RE: CPV Sentinel Energy Project
Application for Certification 07-AFC-3

SUPPLEMENT

In Response to CEC Data Adequacy Review

CPV Sentinel Energy Project

Winter 1988-91 Wintec Windrose

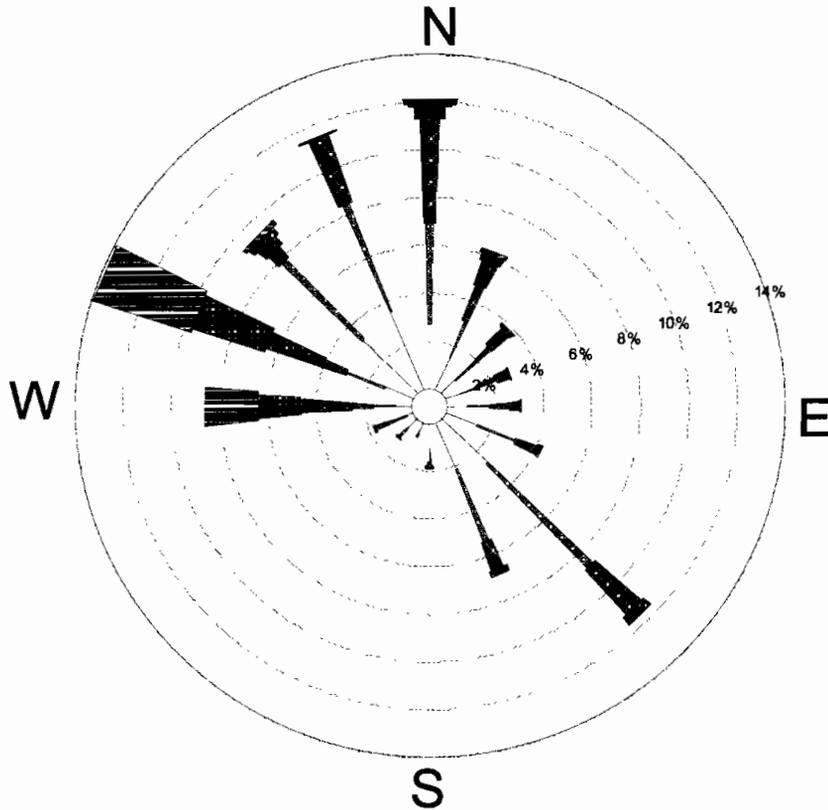
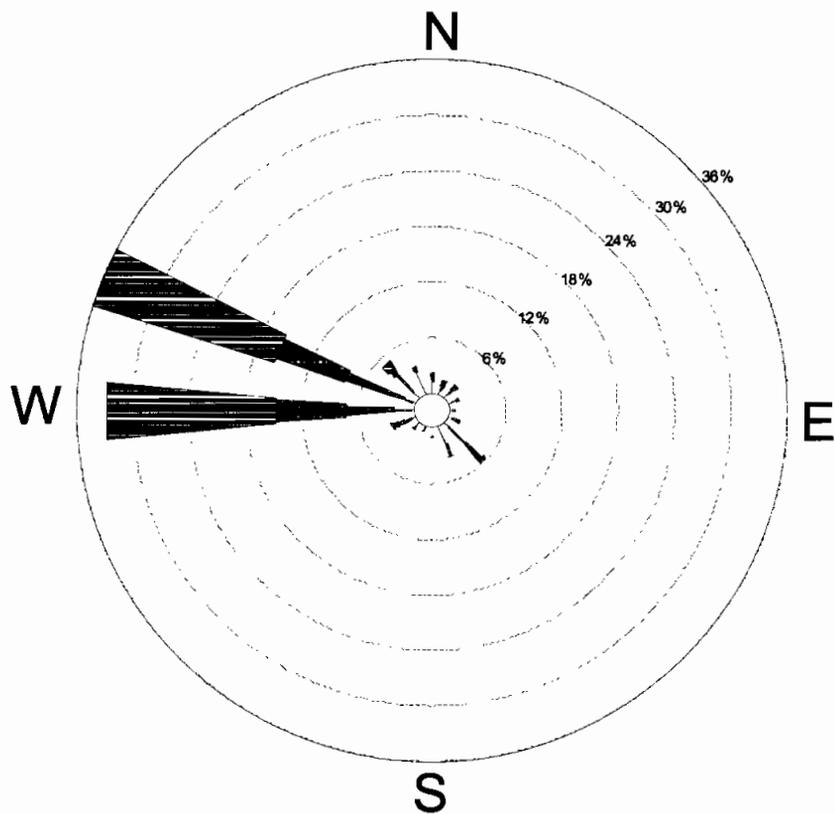
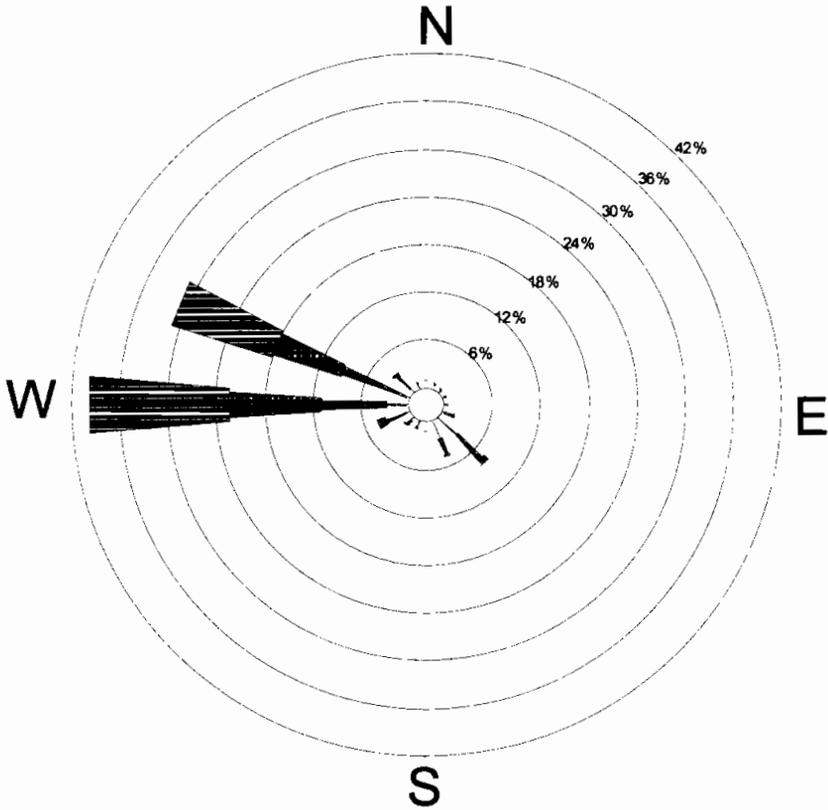
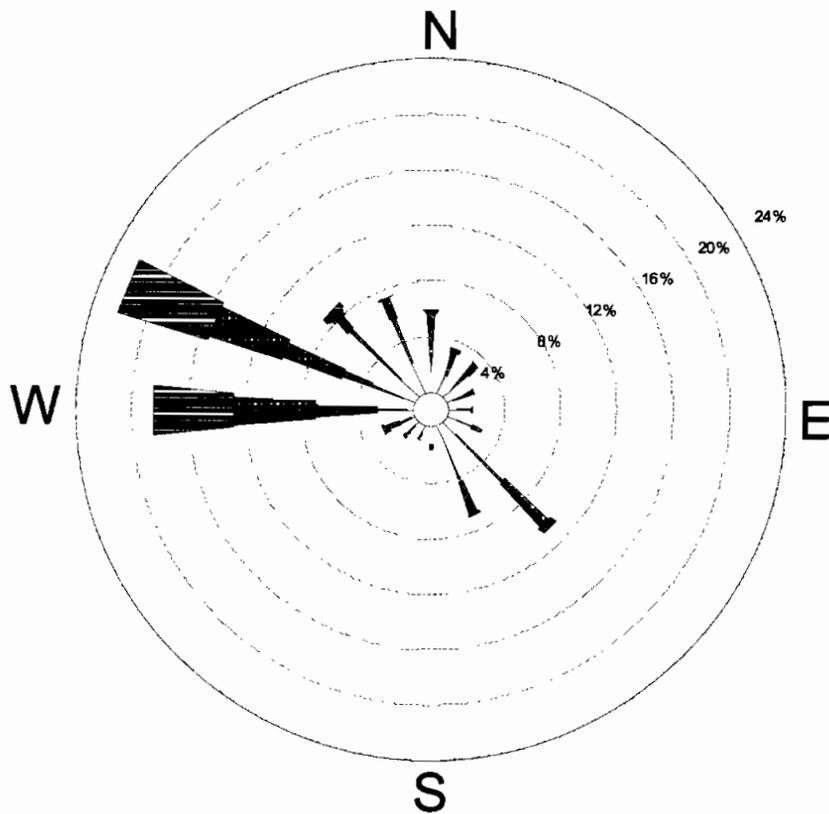
2	Appendix B (g) (8) (H) (ii)	The data shall include quarterly wind tables and wind roses, ambient temperatures, relative humidity, stability and mixing heights, upper atmospheric air data, and an analysis of whether this data is representative of conditions at the project site.	Please provide the quarterly wind tables and wind roses for the meteorological data used in the AFC.	Quarterly wind tables and wind roses are provided in Appendix A.
3	Appendix B (g) (8) (J) (ii)	Potential offset sources, including locations, and quantity of emission reductions;	Provide a list of ERC holders (including the locations of these potential ERCs) that have been contacted to enter negotiations for the VOC, PM10 and SO2 ERCs and/or for the NOx RTCs. You may submit this information with a request for confidential status.	Given the limited availability of PM10 and SOX ERCs on the market, it is anticipated that the project will obtain necessary offsets for these two pollutants from the SCAQMD Priority Reserve. Nevertheless, Applicant has made market inquiries in order to satisfy the due diligence requirement for obtaining offsets from the Priority Reserve. It is anticipated that VOC ERCs will be acquired on the open market, and Applicant has also made market inquiries regarding this pollutant. Given the relatively plentiful supply of NOx RTCs on the

CPV Sentinel Energy Project
CPV Sentinel, LLC
Riverside County, California
July 2007
28067168
URS
FIGURE 2.4-6 (REVISED)

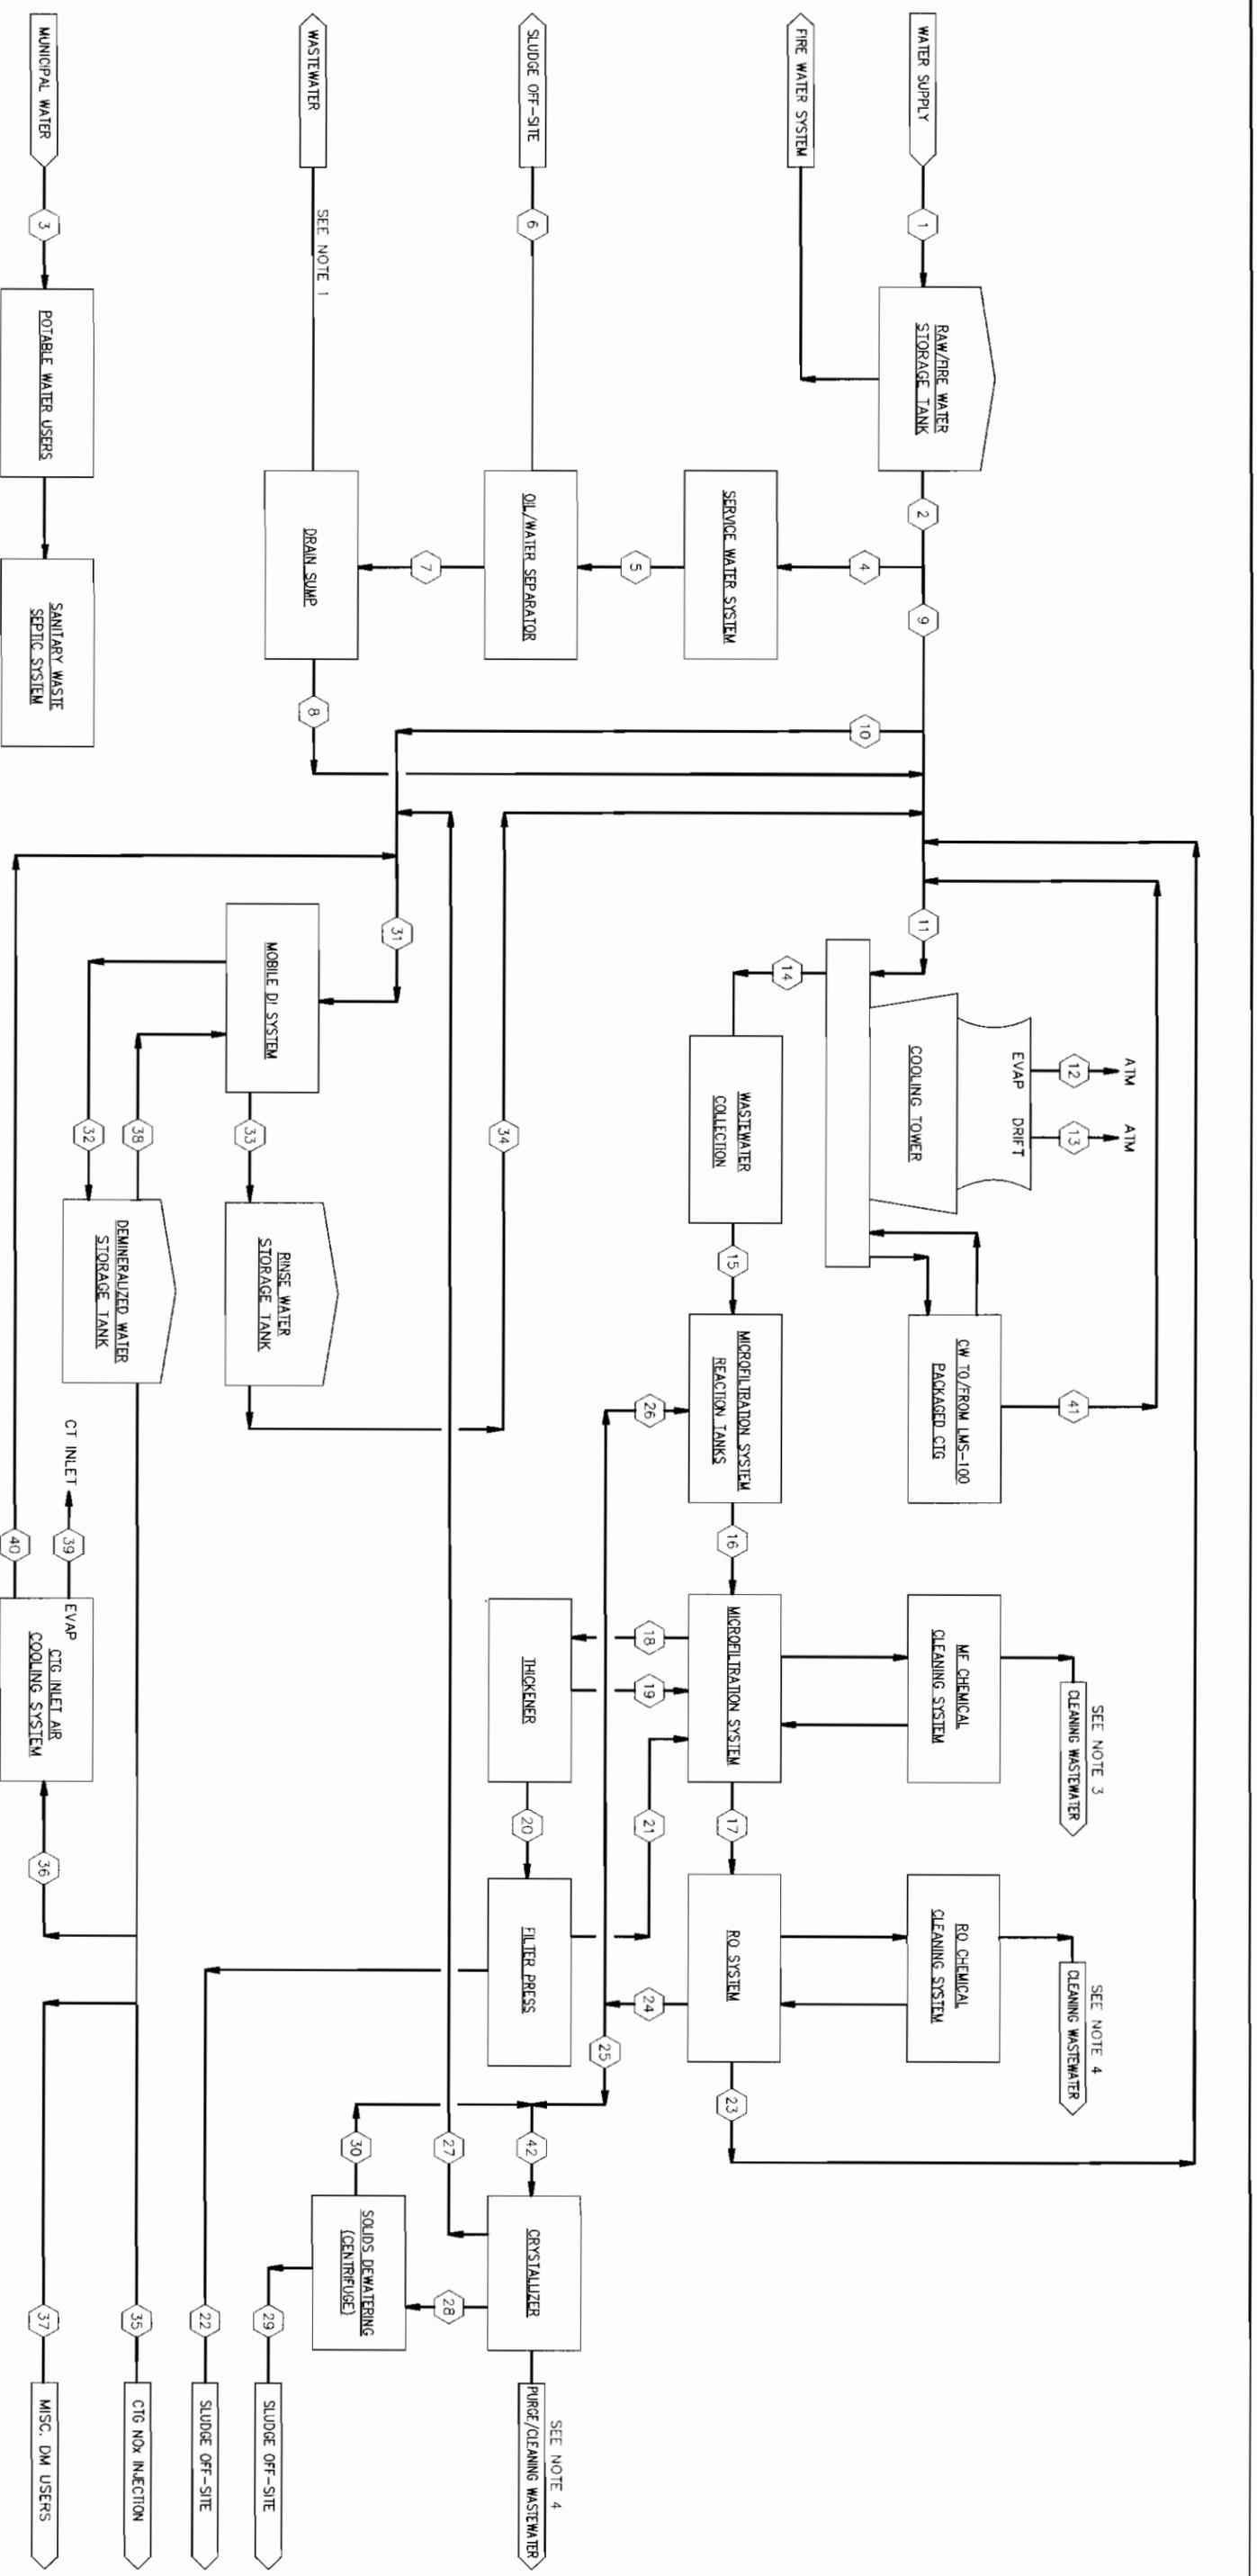
17	Appendix B (g) (14) (C) (vii)	Provide water mass balance and heat balance diagrams for both average and maximum flows that include all process and/or ancillary water supplies and wastewater streams. Highlight any water conservation measures on the diagram and the amount that they	Water mass balance and heat balance diagrams are provided, but they do not show the average and maximum flows. Water mass balance and heat balance diagrams that show the average and maximum flows are required.	Revised tables and figures responding to this request are provided in Appendix H. For the Heat and Mass Balance Diagram, Figure 2.4-4, average and maximum flows for each stream are provided on Revised Table 2.4-3. For

ID	SITING REGULATIONS	INFORMATION	INFORMATION REQUIRED TO MAKE AFC CONFORM WITH REGULATIONS	RESPONSE
		reduce water demand; and		<p>the Water Balance Diagram, Figure 2.4-6, average and maximum flows for each stream are provided on Revised Table 2.4-5.</p> <p>In addition, Figure 2.4-6 provided in the AFC should have referred to Table 2.4-5, not 2.4-4; therefore, a revised Figure 2.4-6 has been provided with the correct Table reference. Revised Tables 2.4-6 and 7.14-7 have also been provided in Appendix H to be consistent with Revised Table 2.4-5.</p>
